Valley of the Winds Wind Farm

Amendment Report

Project name **Valley of the Winds Wind Farm**
Project no. **318001172**
Recipient **ACEN Renewables Australia Pty Ltd**
Document type **Amendment Report**
Version **V2**
Date **27/10/2023**
Prepared by **Clare Butterfield / Belinda Sinclair / Jon Williamson**
Checked by **Belinda Sinclair**
Approved by **Belinda Sinclair**
Description **Amendment Report for the Valley of the Winds Wind Farm project.**

DETAIL B
SCALE 1 / 200

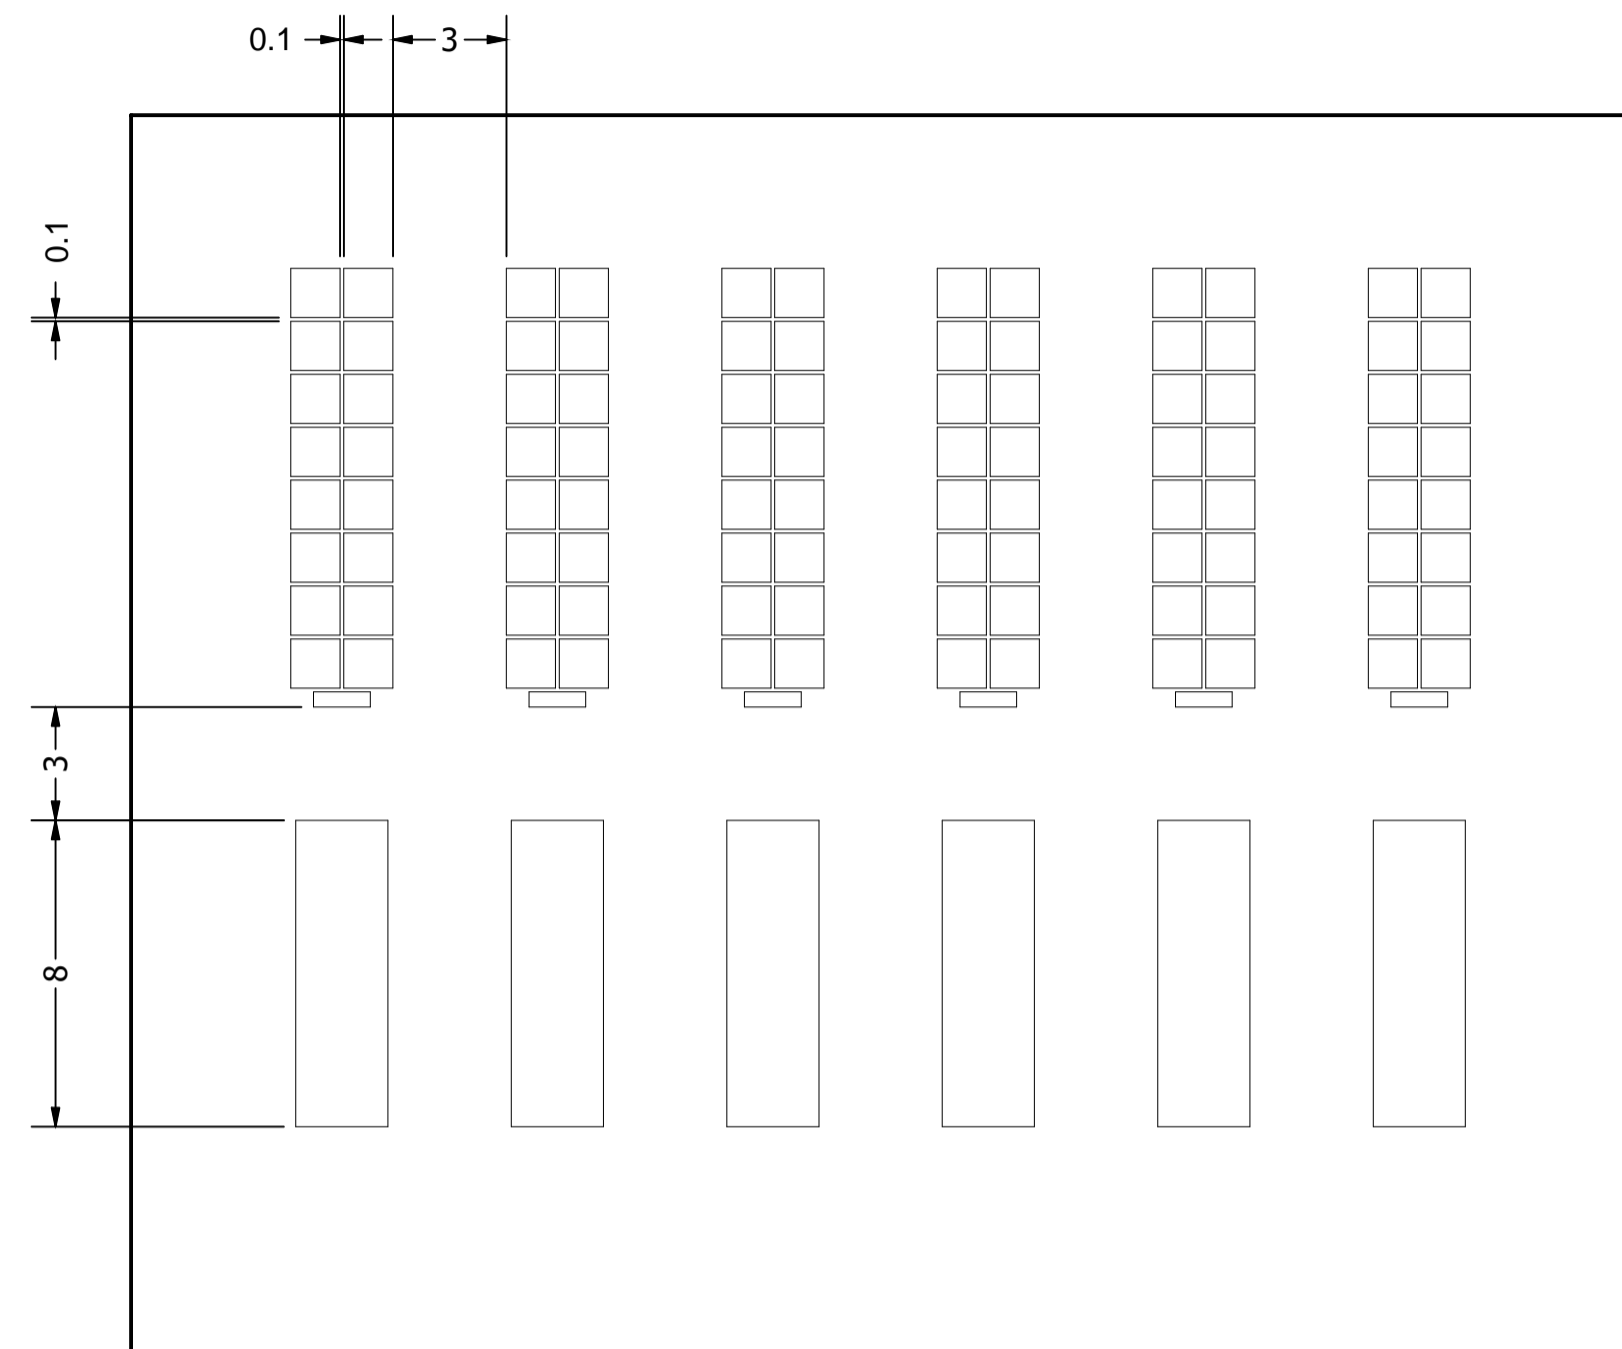
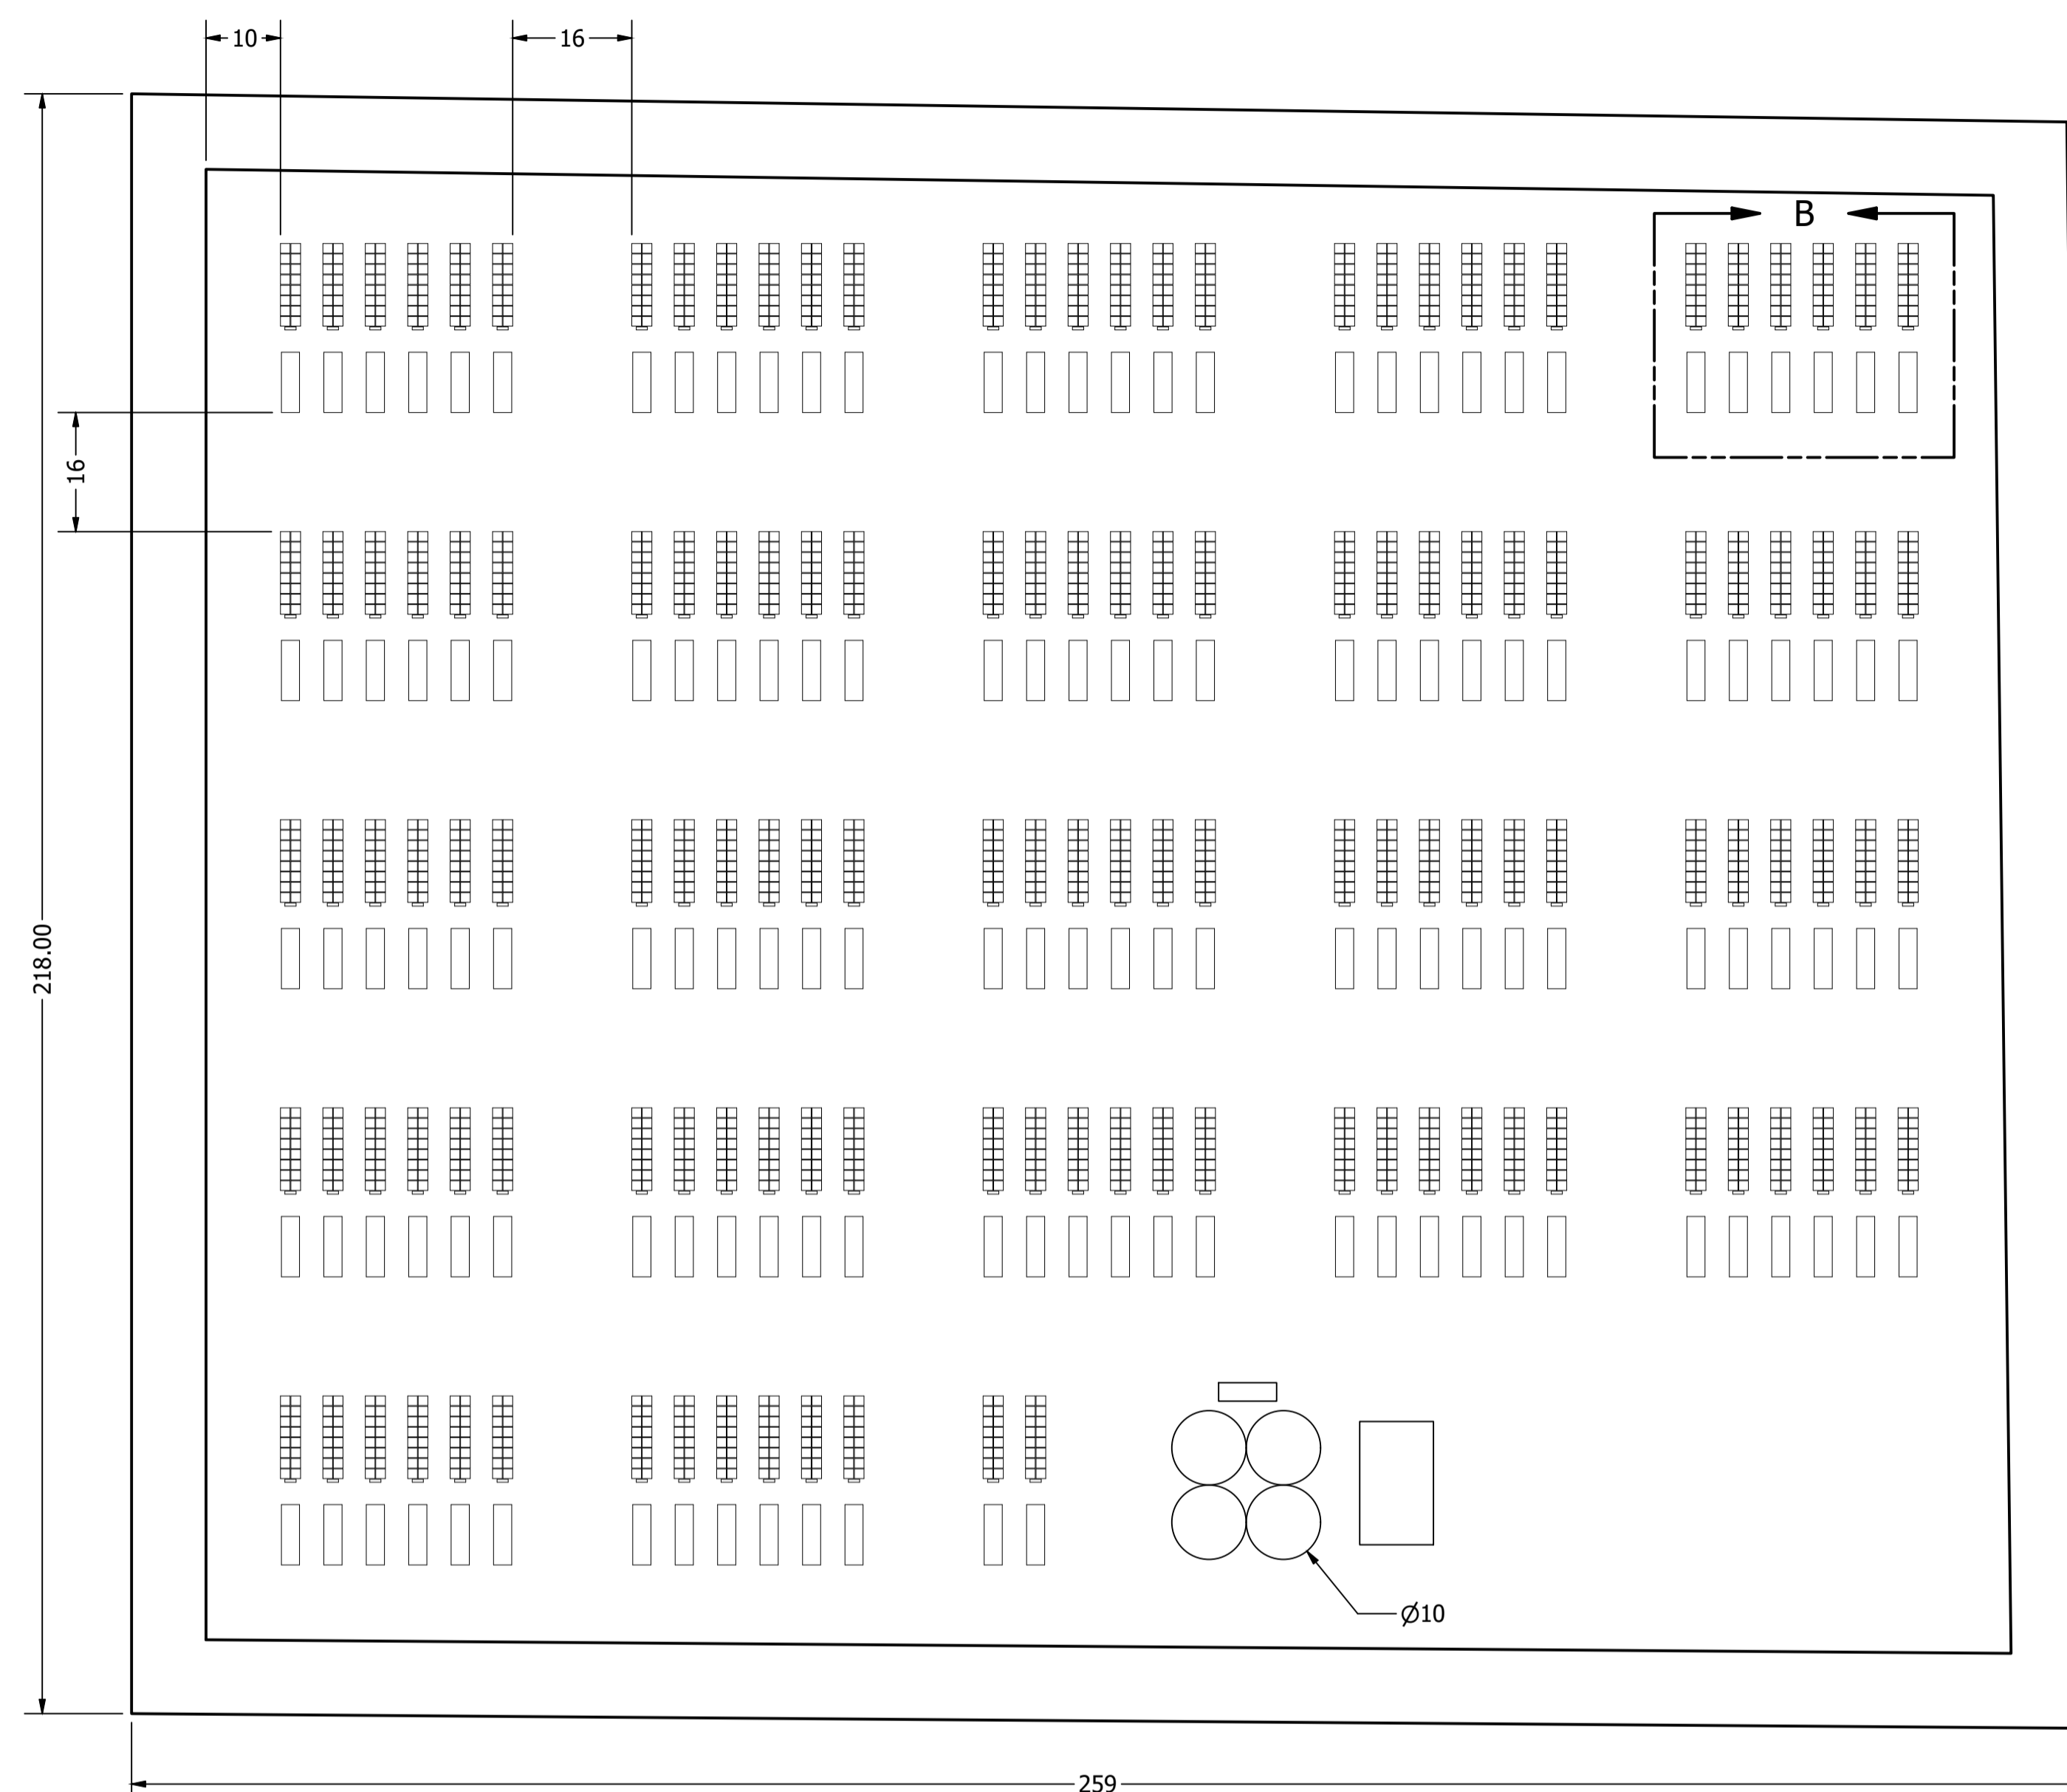
Additional information regarding the location and configuration of the BESS provided, and the PHA provided in the EIS has also been updated in response to feedback from DPE's Hazards Assessment Team. The BESS would be located at the Girragulang central substation, and it is clarified that it would be a centralised 'AC Coupled' BESS. The major components of the BESS are unchanged from the EIS, and would comprise:

An indicative configuration for the BESS is provided in **Figure 3-9** and the updated preliminary hazards assessment is discussed in **Section 6.5**.
